Proposed Amendments to the Streetscape and Sidewalk Improvement Standards

Proposed Amendments to the Uptown Temecula Specific Plan

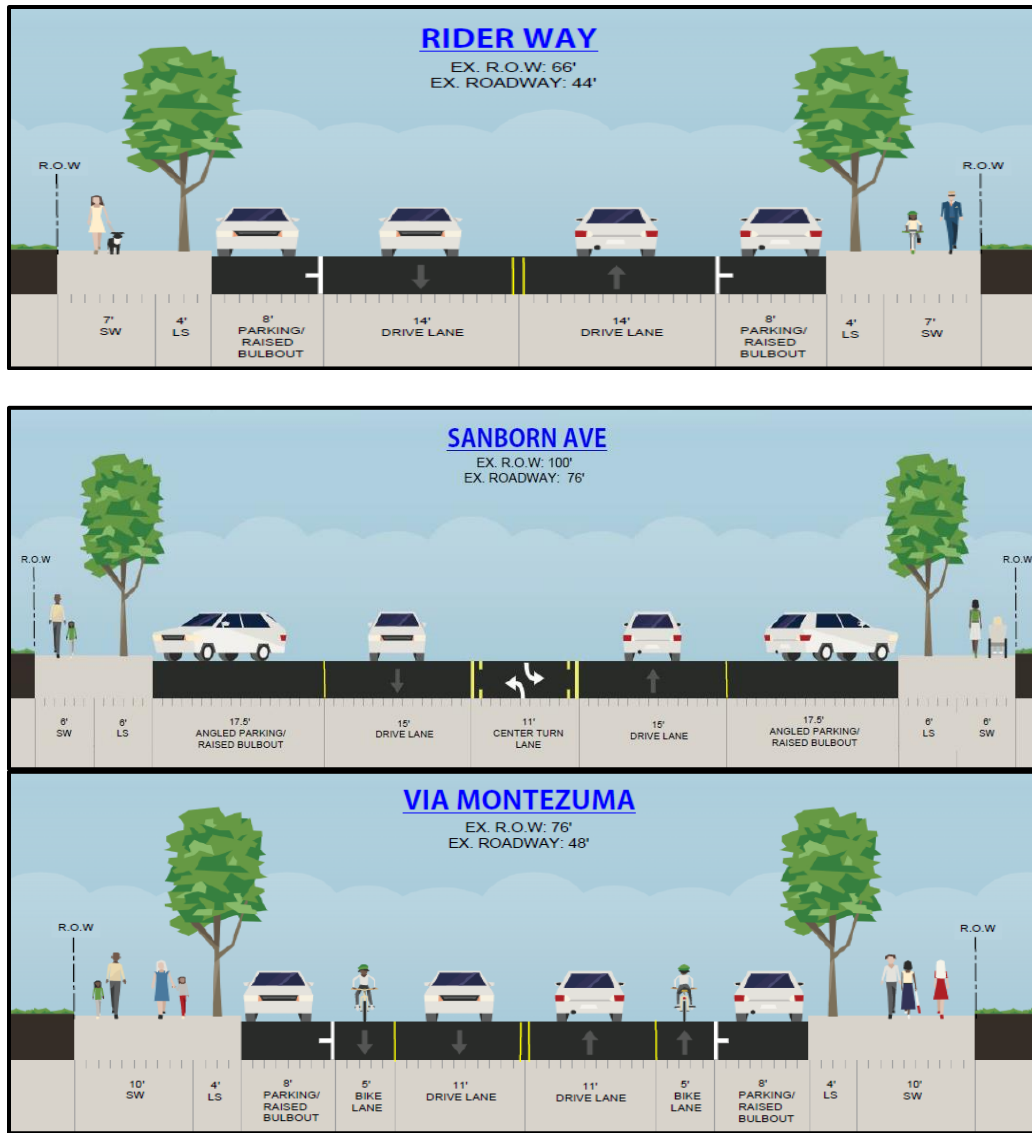
- c. Section I Street Cross Section Standards – Replace the existing street cross sections with the following:

Exhibit 1: Proposed ~~Hypothetical~~ Development of New Streets

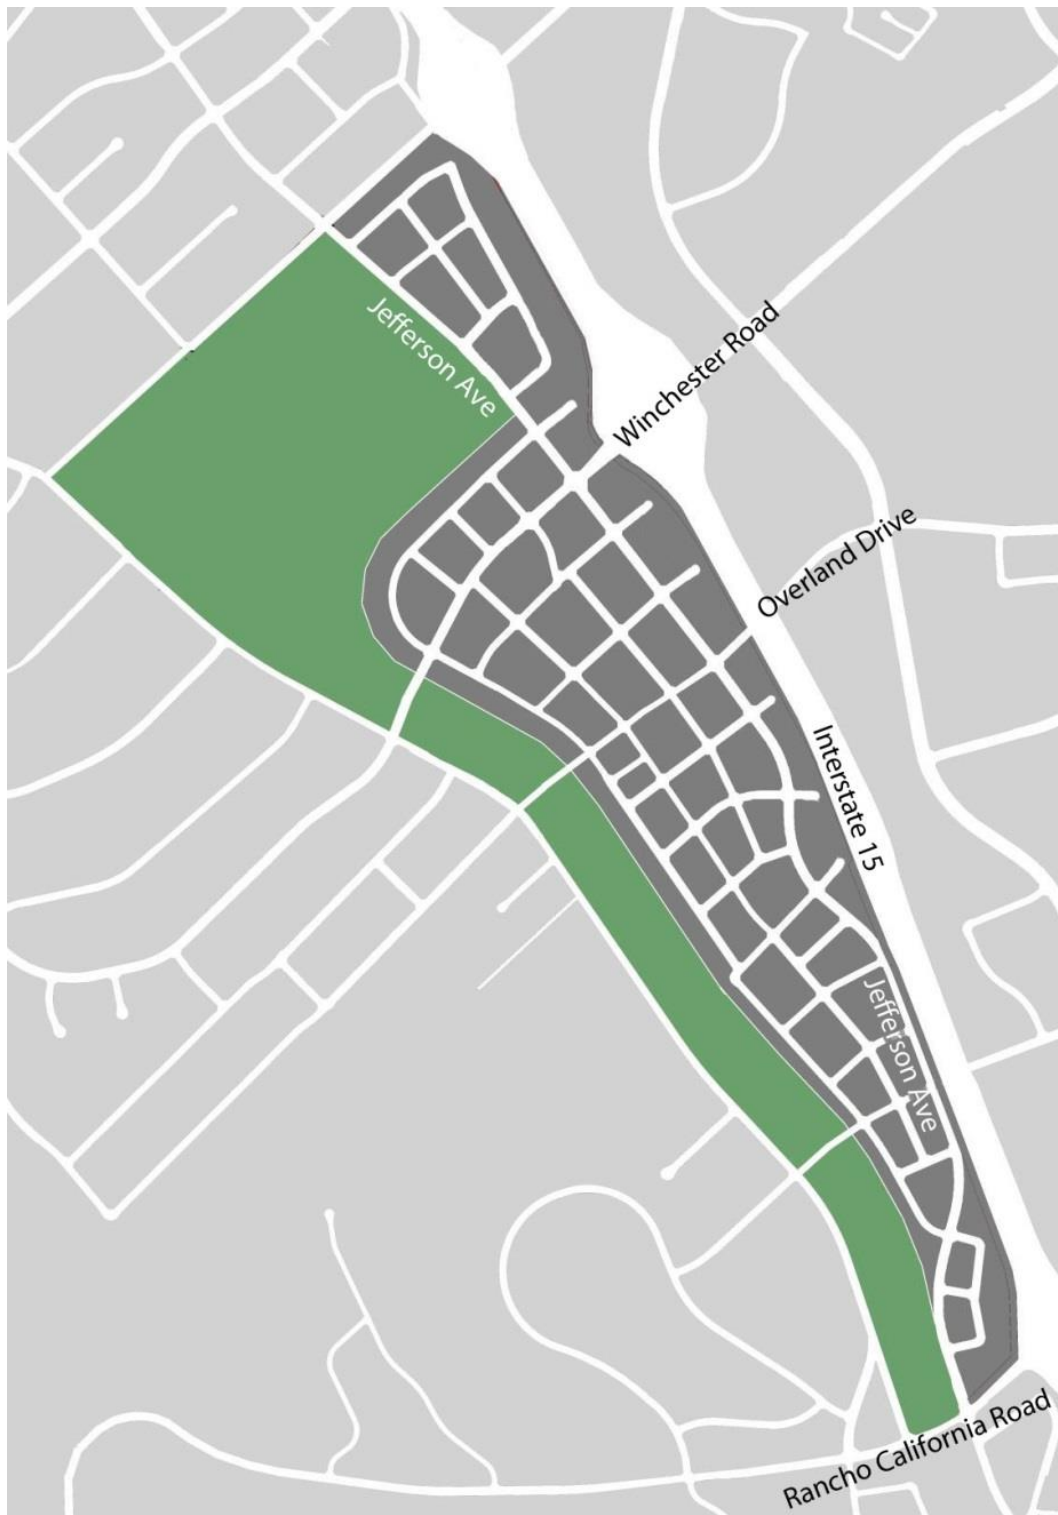
- g. Exhibit 3-13 – Change the title of the exhibit from “Hypothetical Development of New Streets” to “Proposed Development of New Streets” and correct any reference throughout the section

Exhibit 3-13 illustrates the proposed ~~hypothetical~~ development of a street grid in future Uptown Jefferson. The sketch on the left illustrates the existing street grid, and the sketch on the right illustrates proposed ~~potential~~ future streets (dashed lines) that could be added to the existing network. The result is a network of smaller blocks which are more walkable and pedestrian-scaled.

Exhibit -2: Proposed Hypothetical Street Network

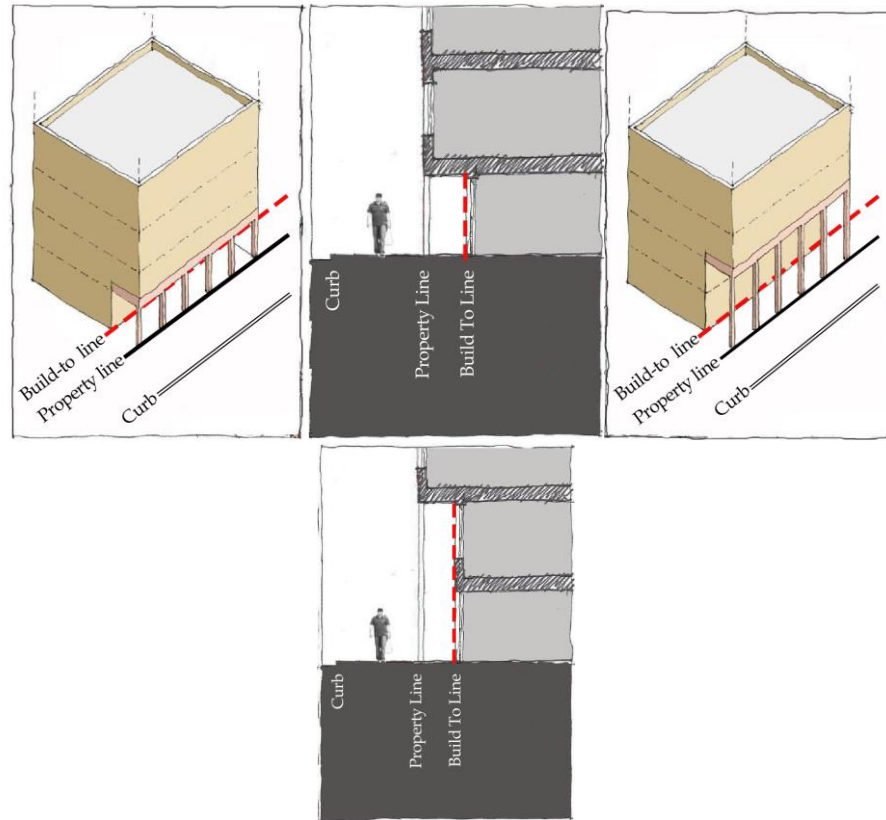
- h. Exhibit 3-14 – Change the title of the exhibit from “Hypothetical Street Network” to “Proposed Street Network” and correct any reference throughout the section

New development projects that propose or require new roads as part of their development shall submit, at the time of application, to the Director of Public Works for approval, a road alignment study that either demonstrates conformity to Exhibit 3-13: Proposed Street Network or provides an alternative road alignment study which shall demonstrate strict adherence to Table 3-14: Block Standards and provide equal or greater connectivity as Exhibit 3-14: Proposed Street Network.

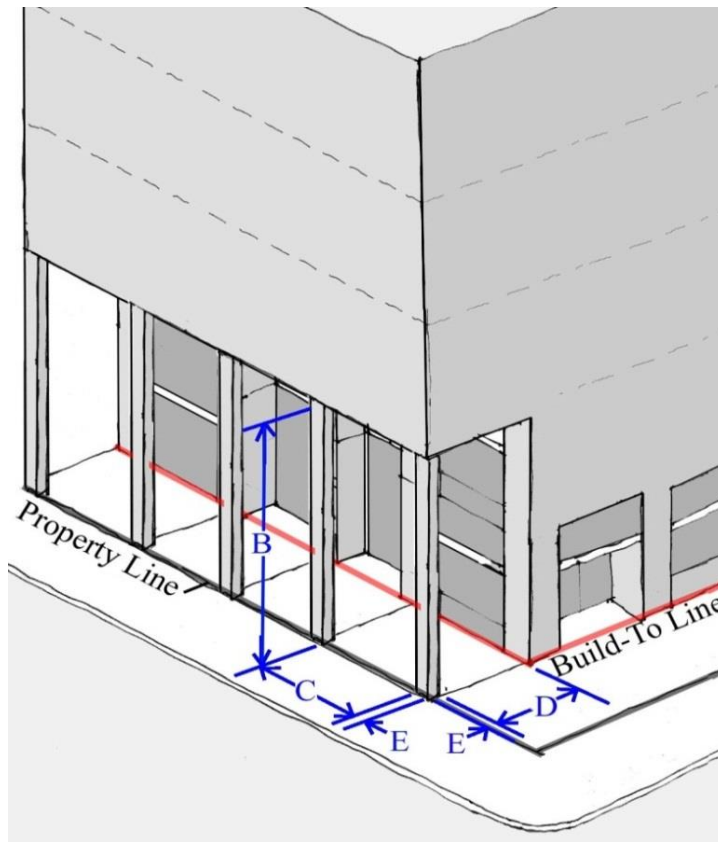
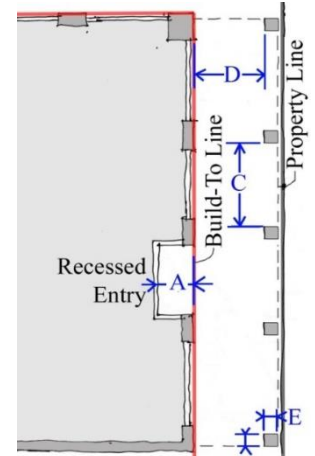
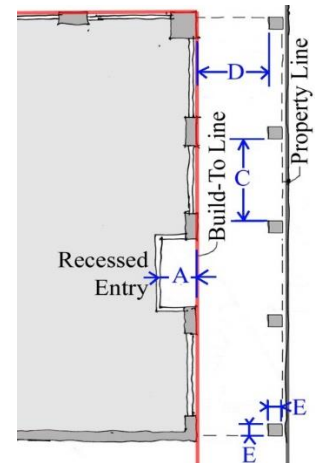
- a. Exhibit 4-11 Allowable Frontage Types – Modify the graphics to show the correct building placement for Arcade and High Arcade frontage types

- b. Replace the term “Tall Arcade” with “High Arcade” for consistency throughout the chapter

- c. Exhibits 4-18, 4-19, and 4-20 – replace “Tall Arcade” with “High Arcade” for consistency
